SEWAGE DISPOSAL SYSTEM

DEPARTMENT OF HEALTH AND MENTAL HYGIENE

SUBDIVISION Holly Hills LOT 7 ROAD 3323 Sang Road

LOT 7
SITE PLAN

A 50619B

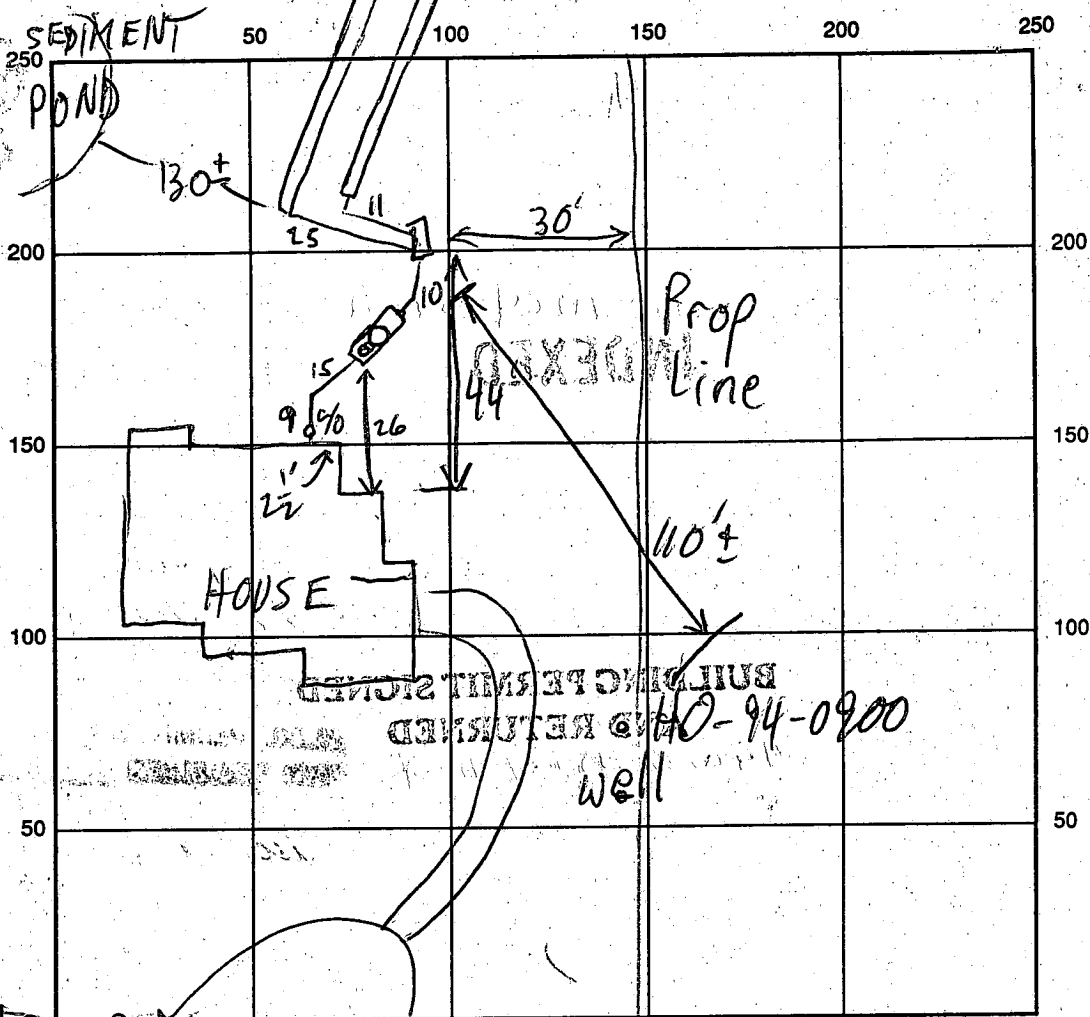
REMARKS: 12/18/96 TRENCHES ① & ② OK; PREV CONV W/RICK WMS. BAVE
OK TO MOVE TRENCHES HIGHER DUE TO H₂O CONCERNS, BUT PIPE
2 1/2 LOWER @ HOUSE WALL THAN BP PLAN, SDA REPAIR SEEMS LIMITED
SO LAYOUT CHANGED TO 2-120' TRENCHES; ADD 40' ONTO EACH
CONTINUE MR 12/20/96 TRENCHES LENGTHENED TO 120' EACH, OK TO COVER.

1/7/97 WPI OK TO COVER ground wire not connected to casing KM

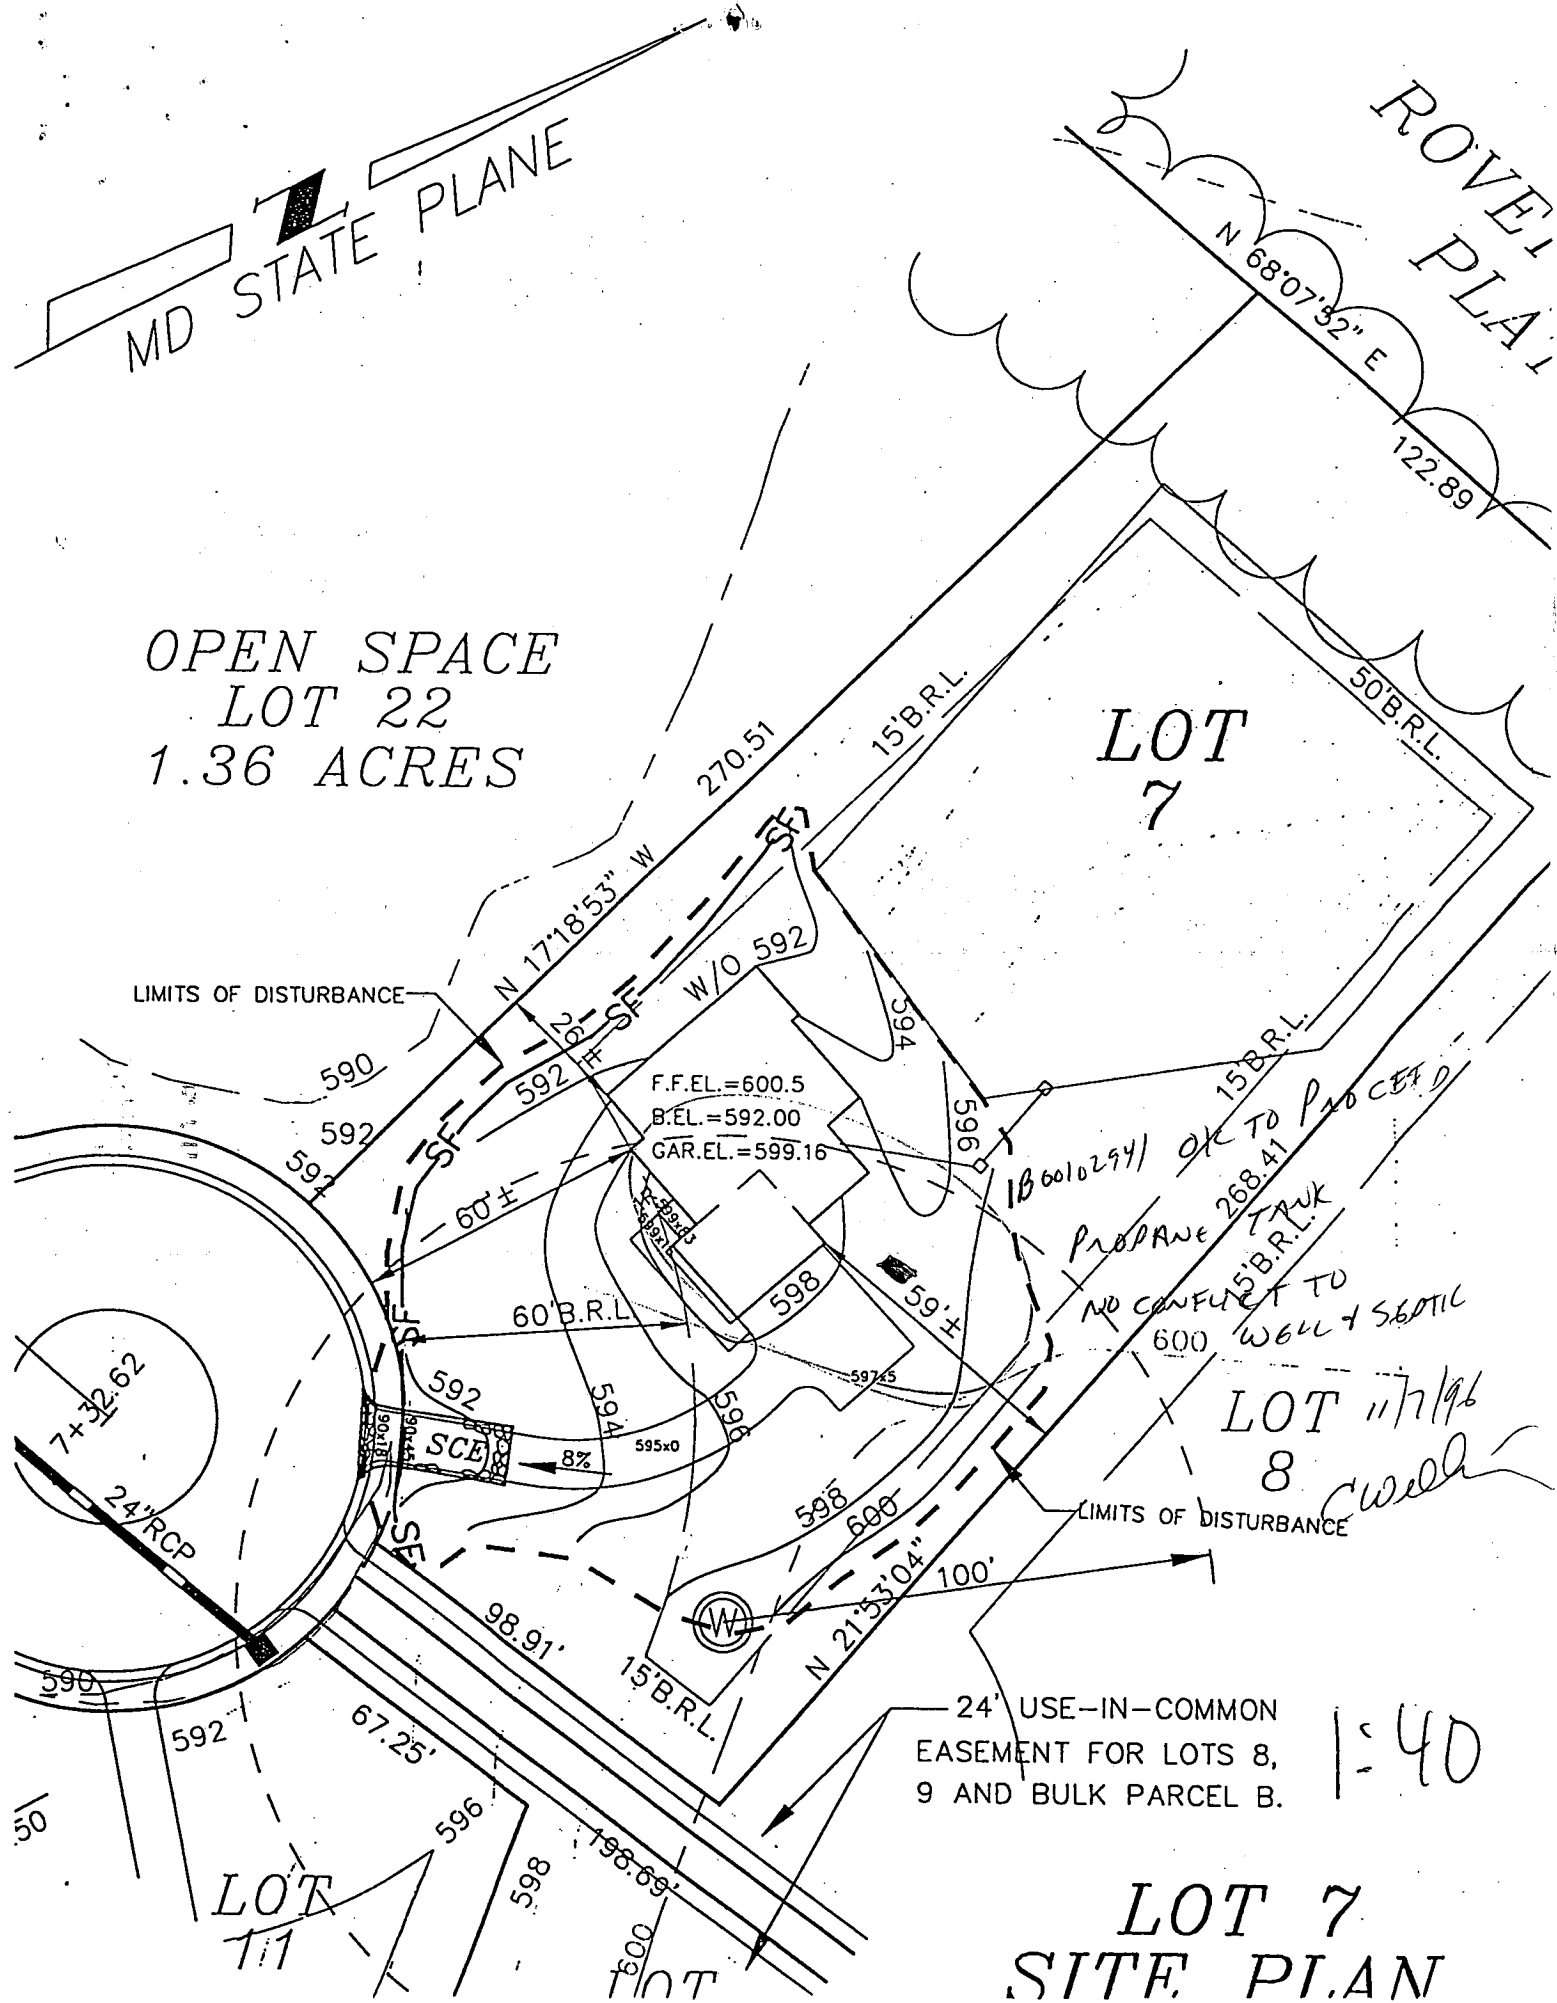
PROANE TANK
NO CONFLICT TO
600 WELL + SEPTIC
186010294 OK TO PROCEED

HOLLY HILLS, SECTION I
PLOT PLAN

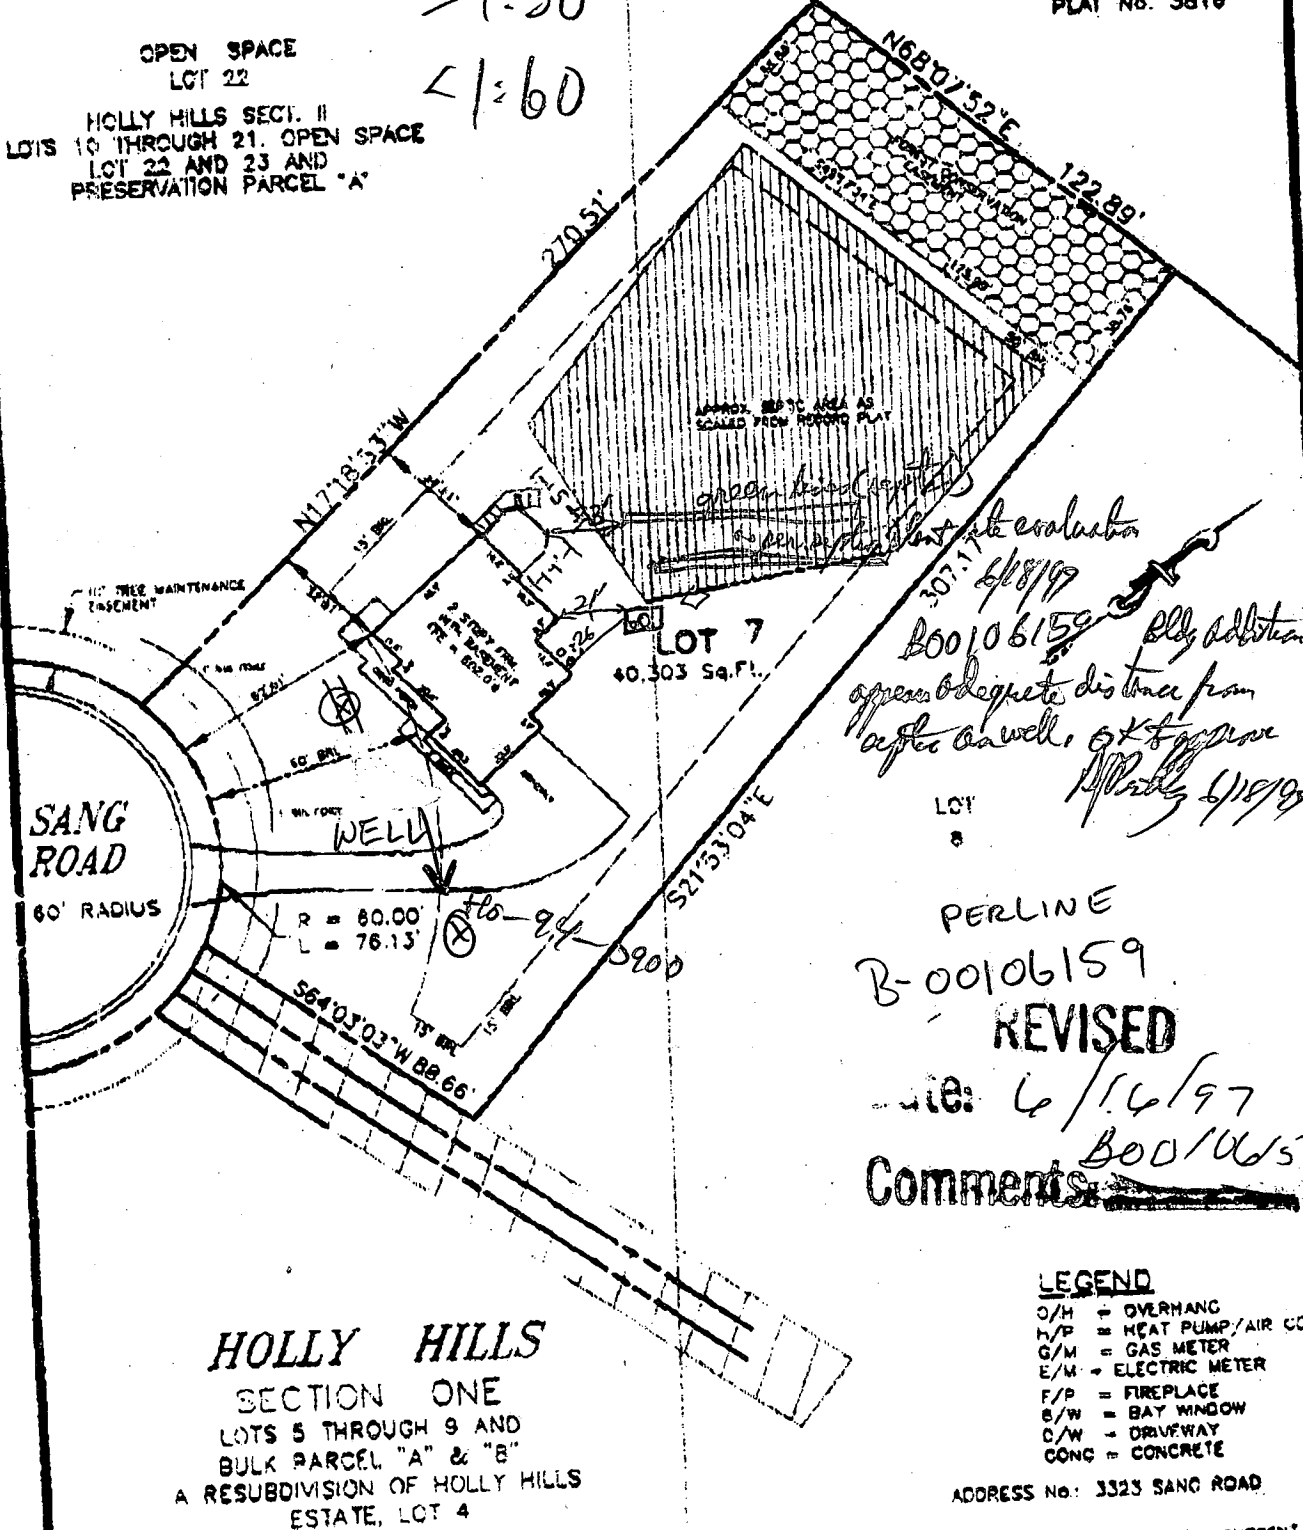
6/18/97
B00106159
open adequate distance from
water as well, OK to approve
Perline 6/18/97

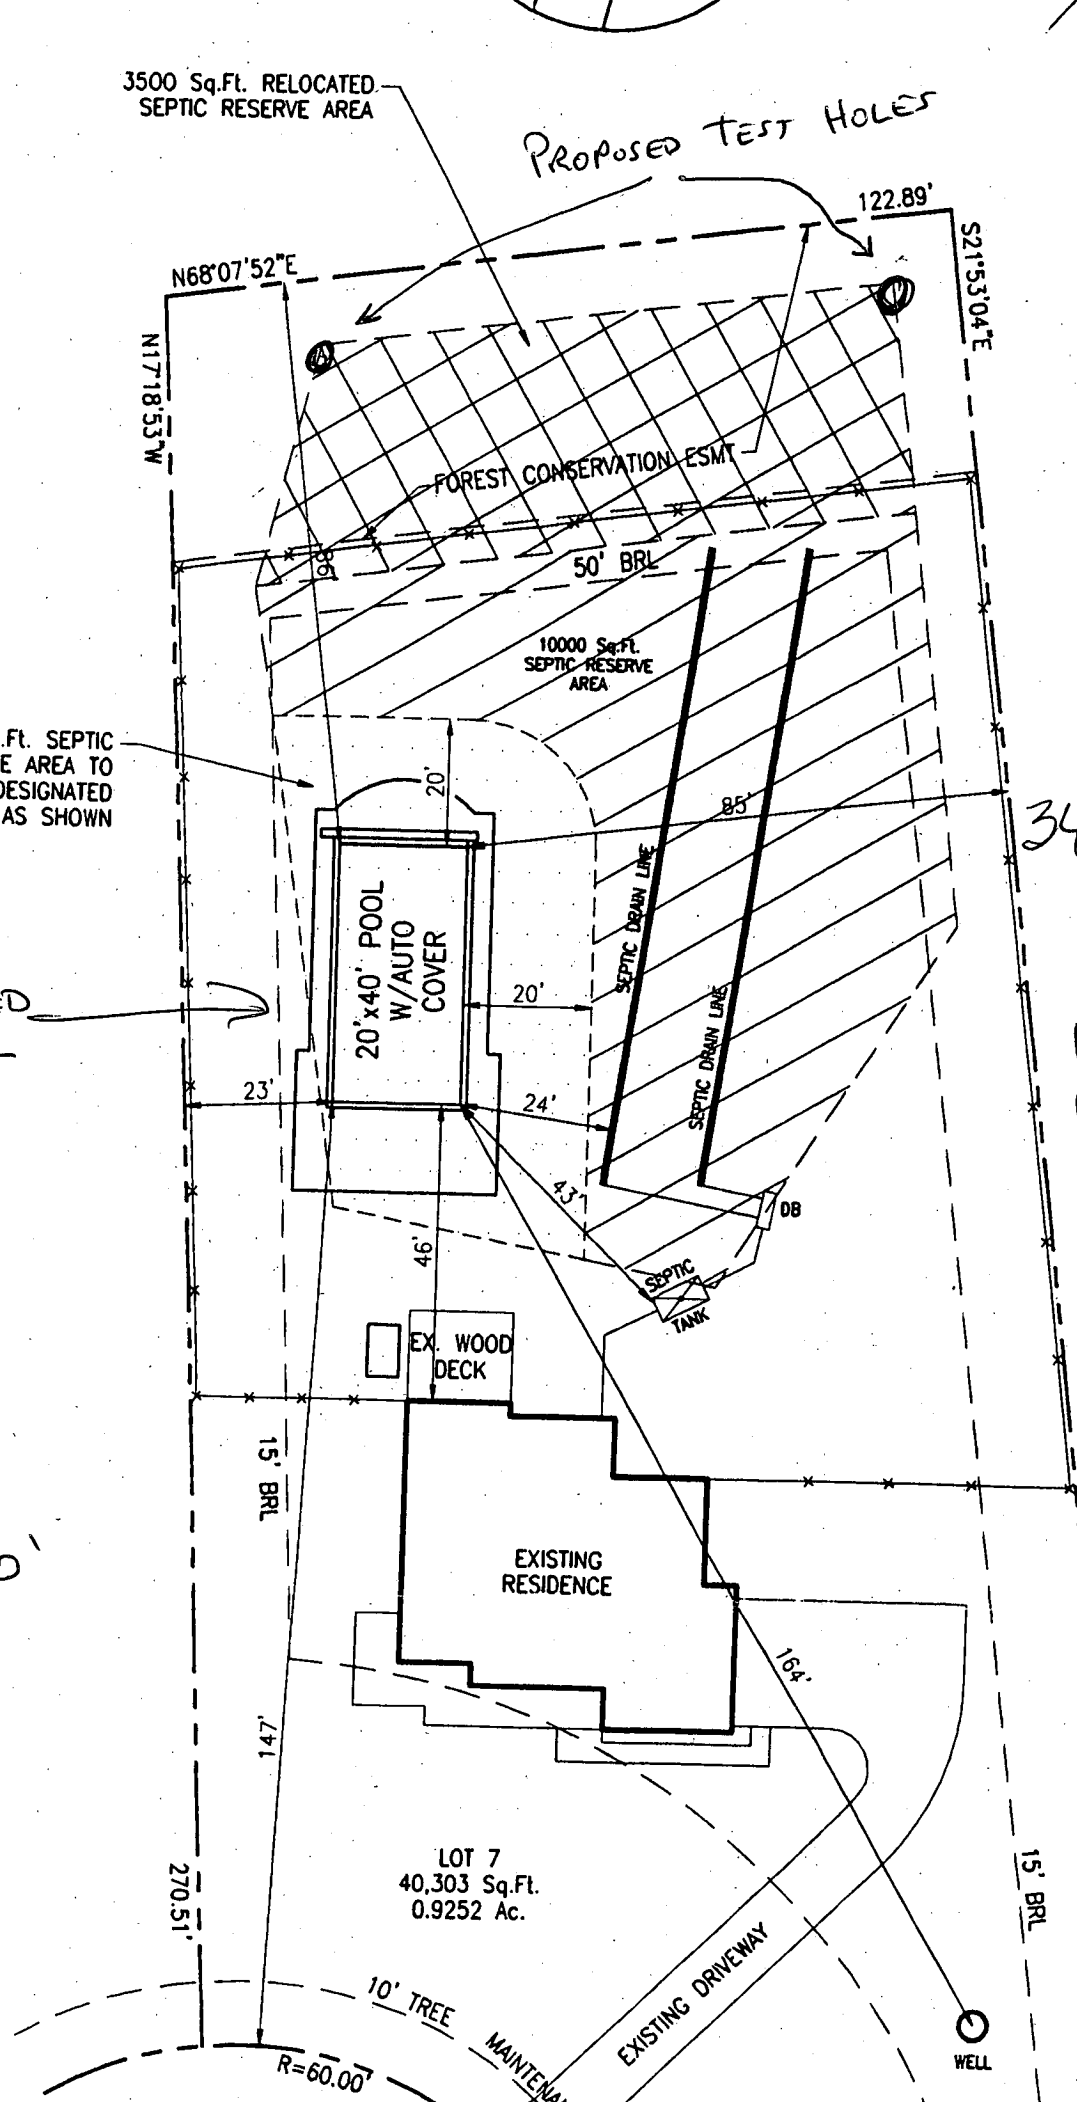
3500 Sq.Ft. SEPTIC RESERVE AREA TO BE REDESIGNATED AS SHOWN

345 lin ft.
Fence &
10/4/00 CM
POOL AS
PREV. A
POOL
AND POOL
REVISIO.
